23 September 2020

SUBMISSION - 2020 REVISED DRAFT MASTER PLAN FOR THE CARTER STREET PRECINCT (Site C – Meriton Site)

Drawing Number **DA209** Revision

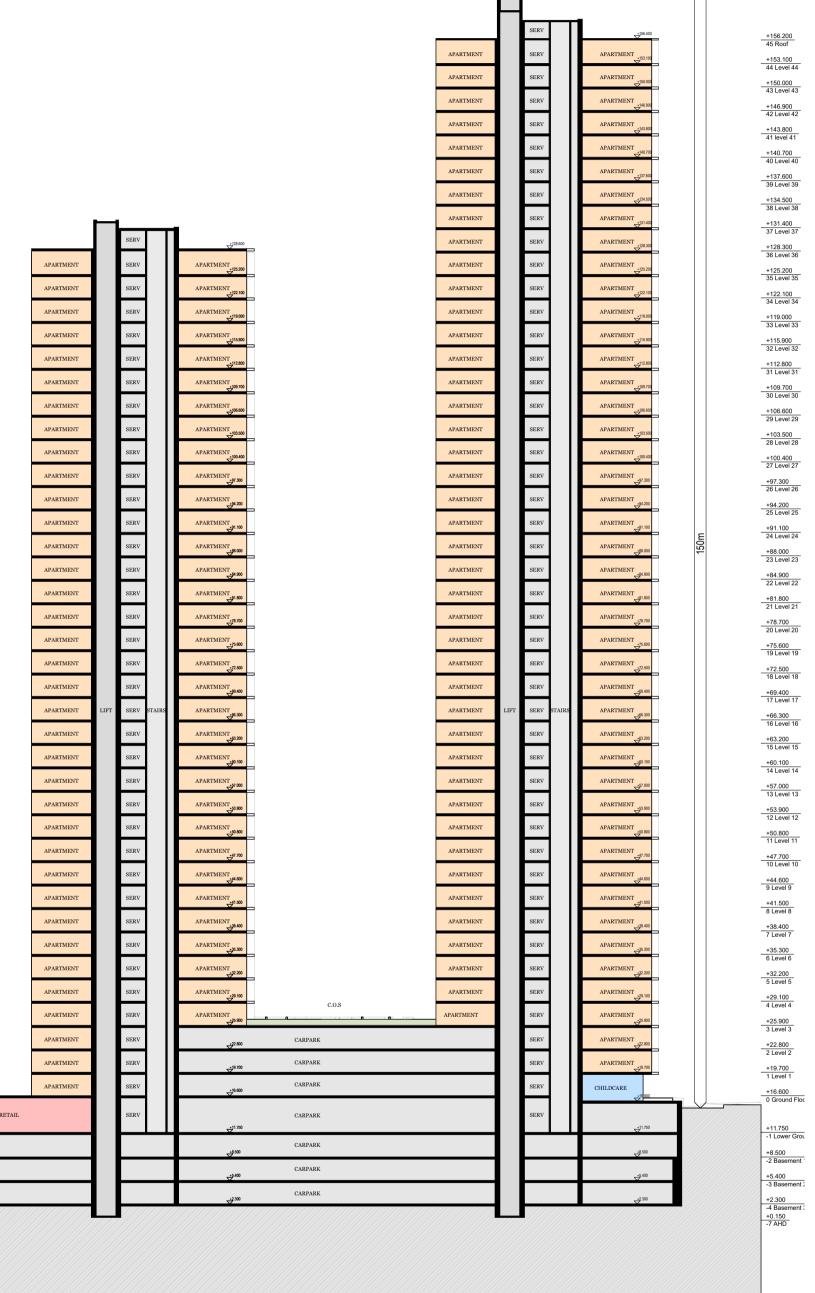
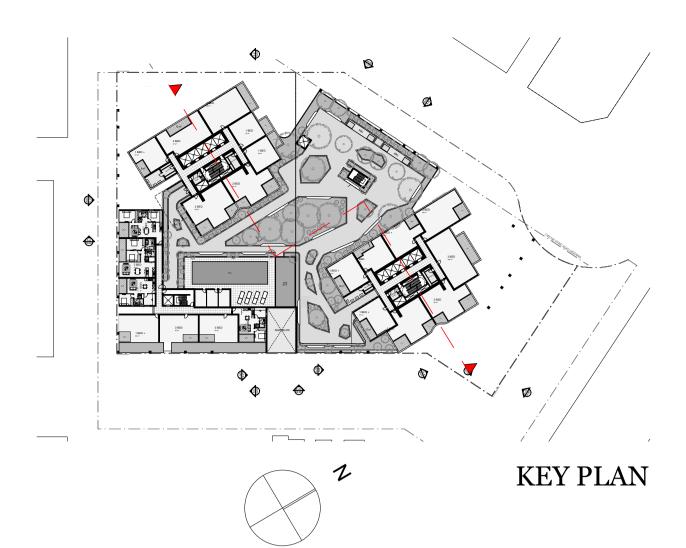
- 1. Building heights We seek a slight increase in building heights on Phase 3 to 150m to accommodate plant and lift overruns. See attached plan (Attachment A) and associated advice from our lift consultants (Attachment B) to verify the height requirements. As shown in the plan, the overall height of the buildings is no greater than 45 storeys as agreed, however the lift overrun and plant requirements require additional height to accommodate the latest technology and meet respective standards. Please amend accordingly upon implementation.

Drawing Number **DA308** Revision

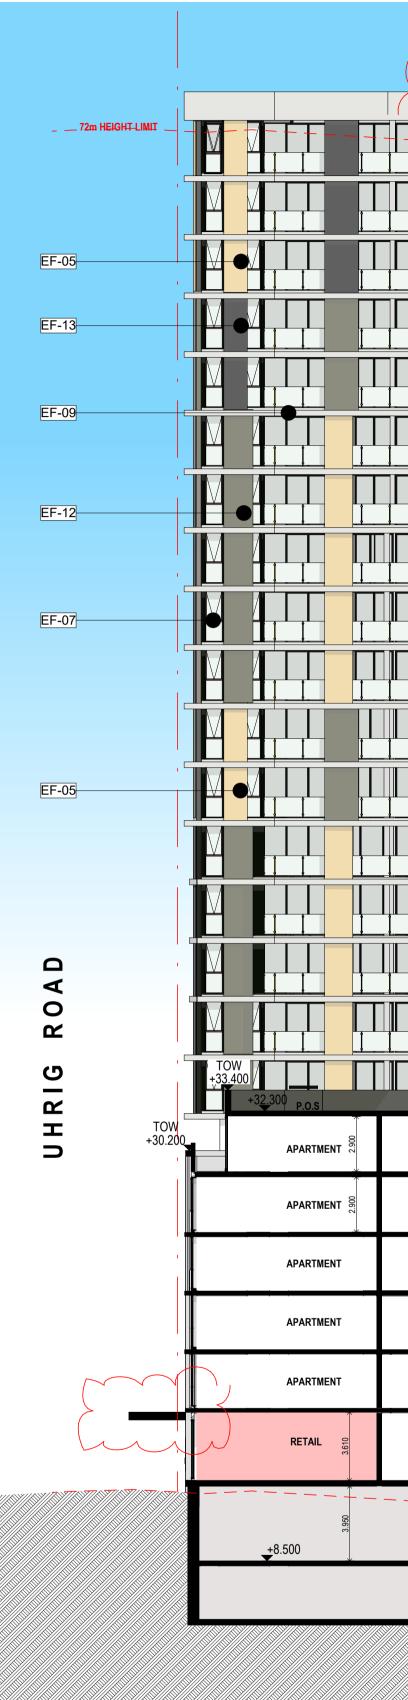
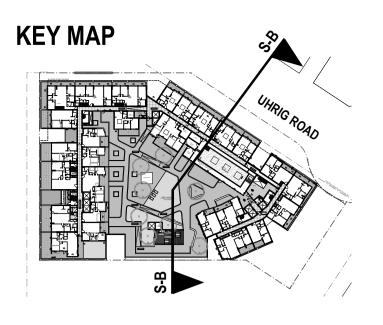
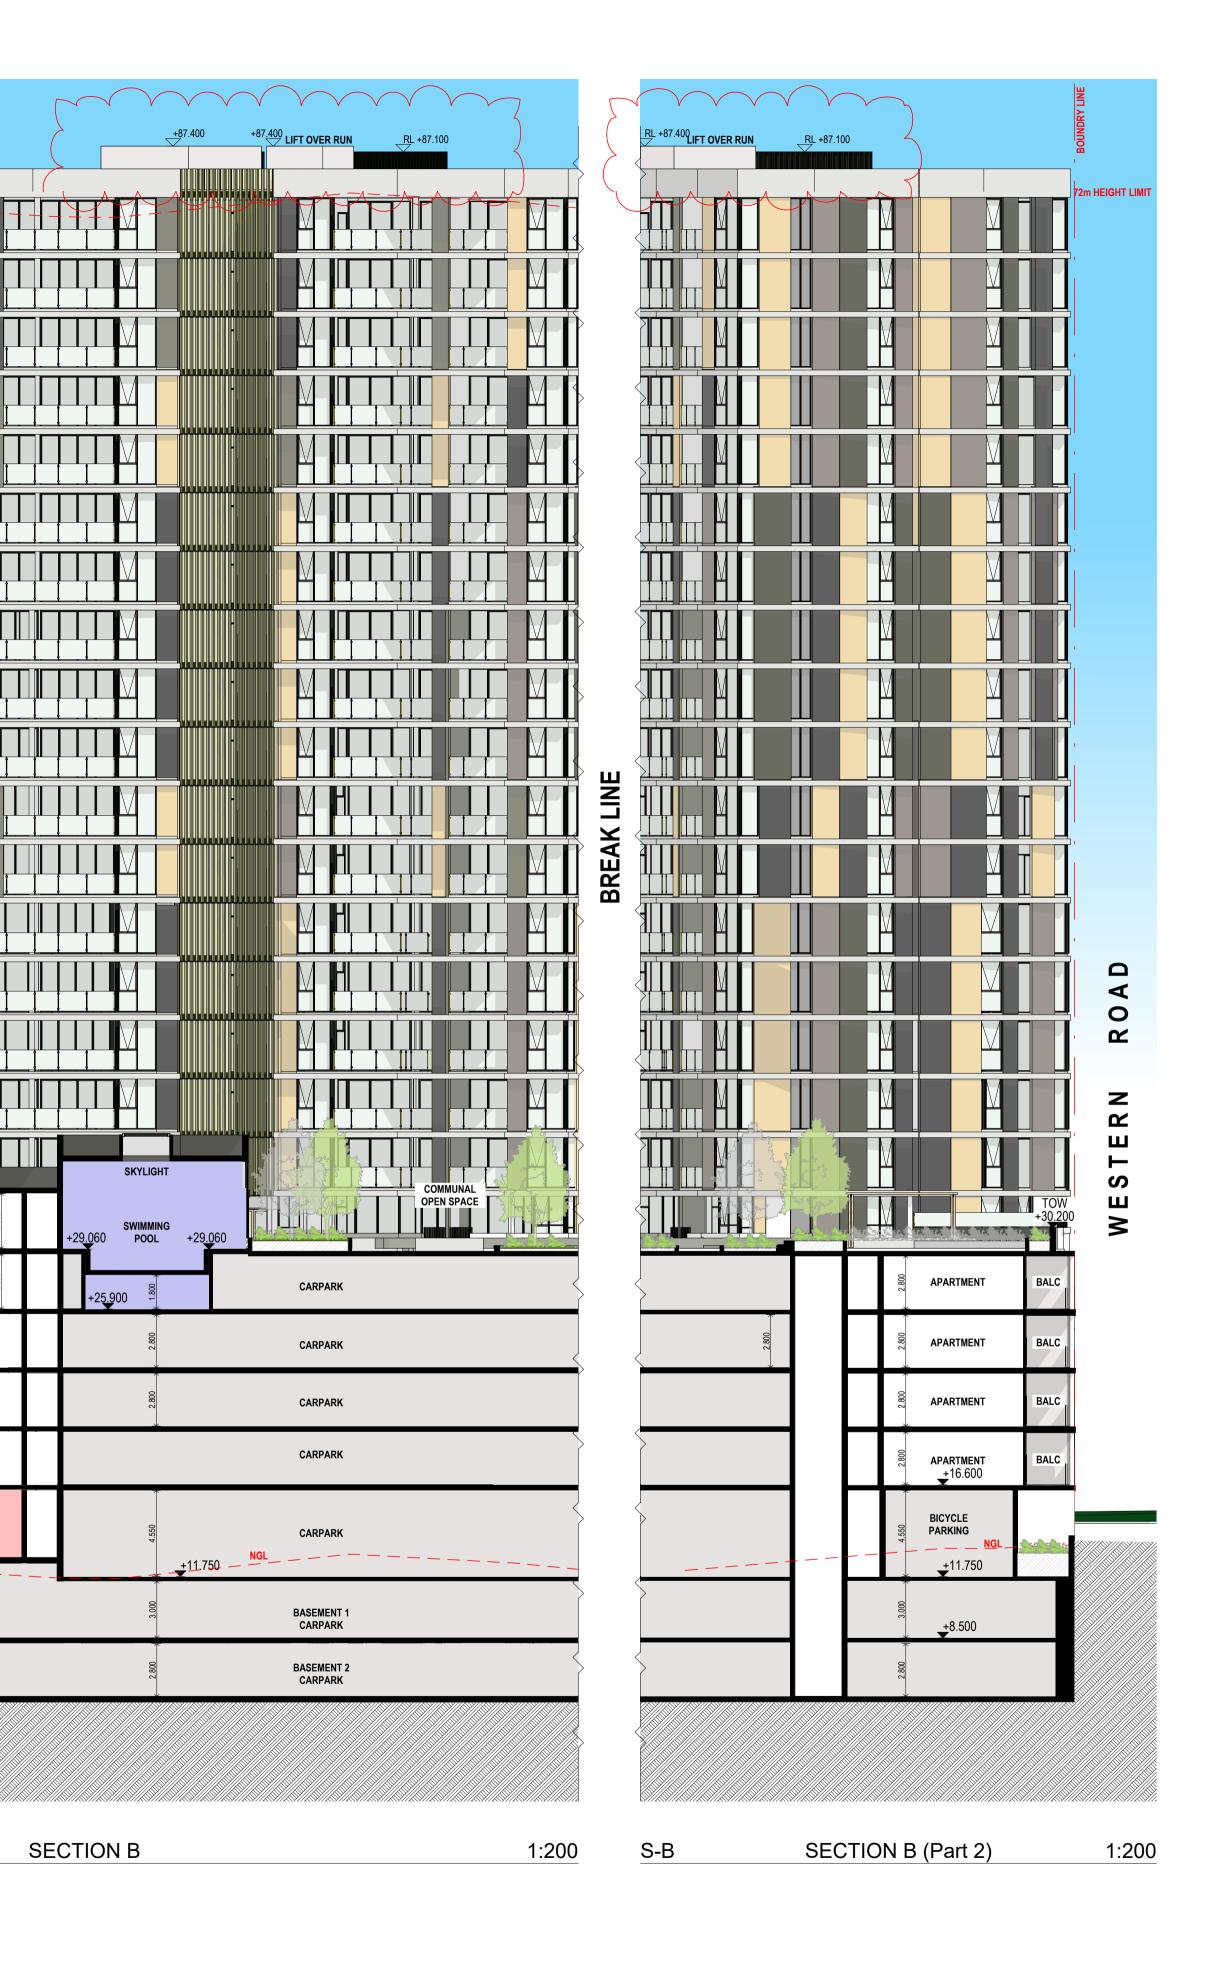
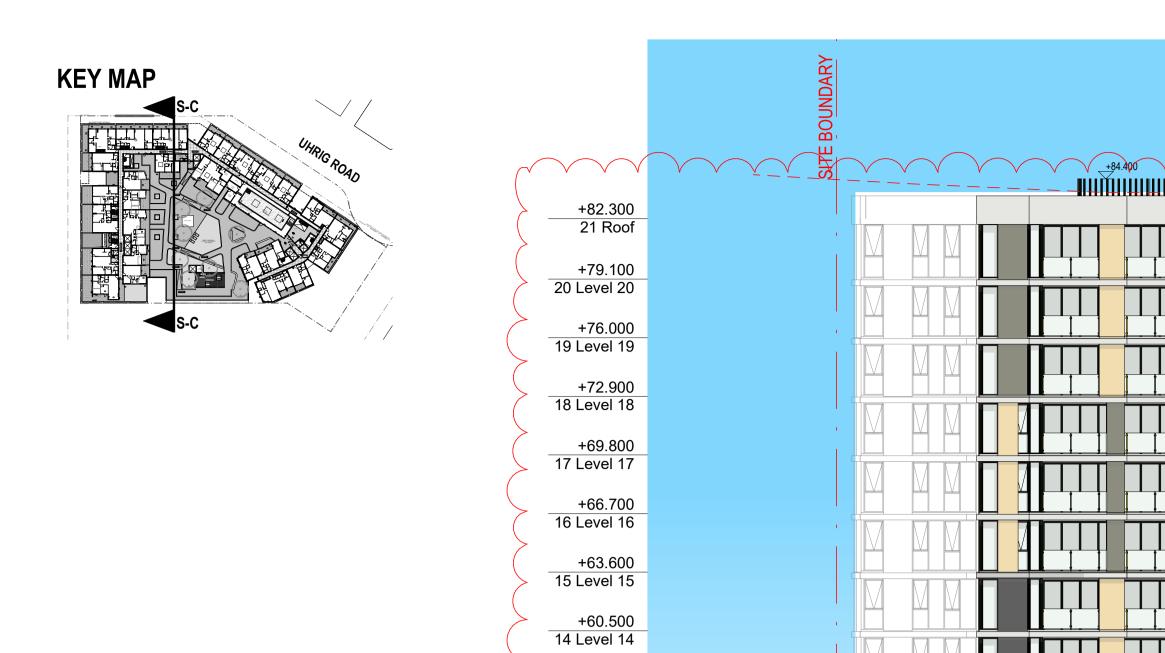
6. Podium Heights – As demonstrated in the current Phase 3 plans (section provided in Attachment F), the Street wall is 5-6 storey's and the same street wall heights will be replicated under the New DA with the possible need for some additional height as we finalise the plans. Accordingly, the proposed street wall height controls for Phase 3 must adopt the maximum 7 storey's as applied elsewhere in the precinct. Please amend the controls accordingly prior to the finalisation of the Development Framework.
